Determination 2016/027

The refusal to issue a code compliance certificate for 14-year-old alterations to plaster-brick house at 526 Ellesmere Road, Ladbrooks, Christchurch

Figure 1

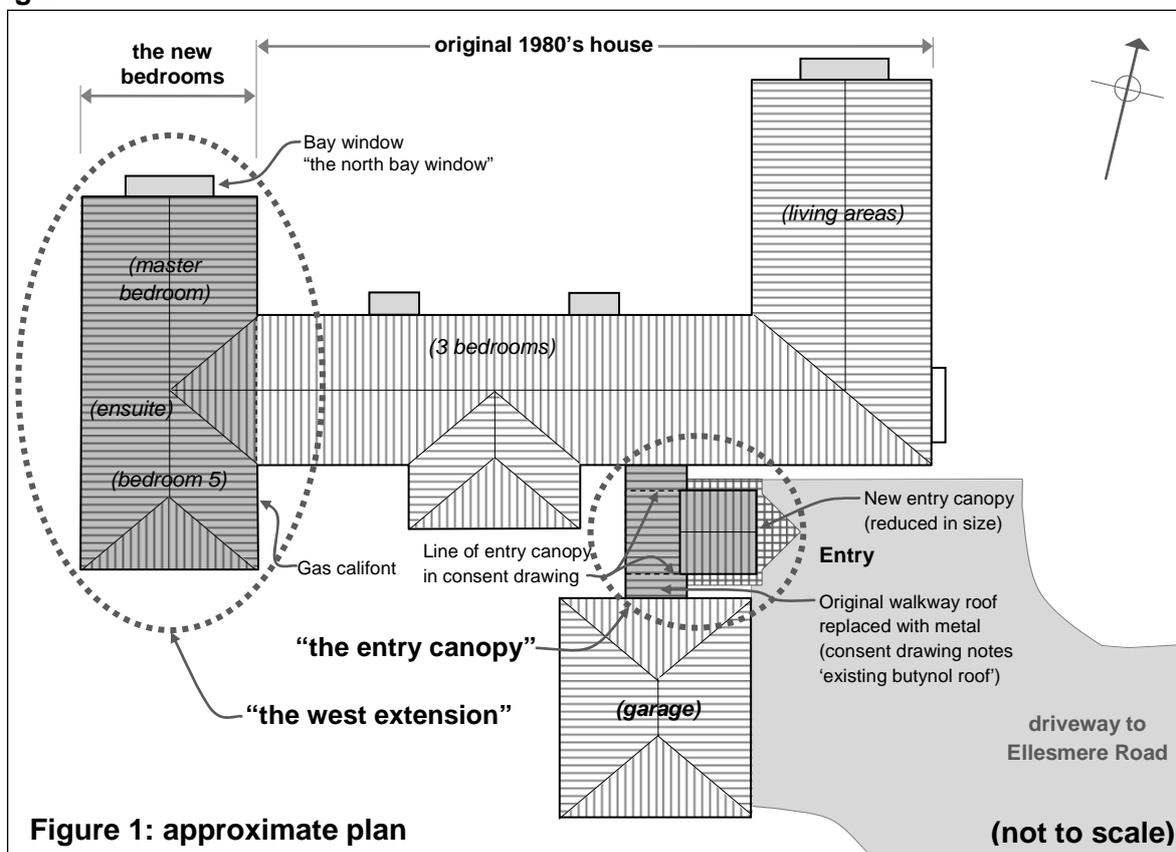
2.3 The addition extends the original house as shown in Figure 1; using the same form and materials as the original house. Except for a 150mm verge overhang to the north gable end to match the original north elevation, the 45° pitch roof to the west extension has no eaves or verge overhangs.

2.4.1 The west extension forms a new bedroom wing and the alterations to the existing house include the construction of a new entry canopy to the original covered walkway on the east elevation. The two areas of new building work are shown shaded in Figure 1.
